FIELD NOTES

PROJECT: Rockwood 10

SUBJECT: Paver Band and General Site Walk

2. Plaza Paver Band

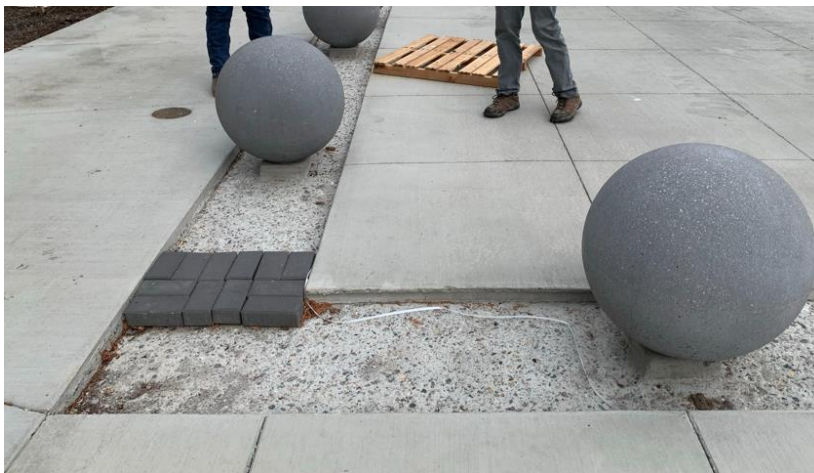
- a. Team reviewed on-site and confirmed polymeric sand set installation is acceptable (see RFI 474)
- b. Width of concrete band varies by at least 75". Subcontractor will have to take great care to evenly distribute pavers and joints for consistent appearance.
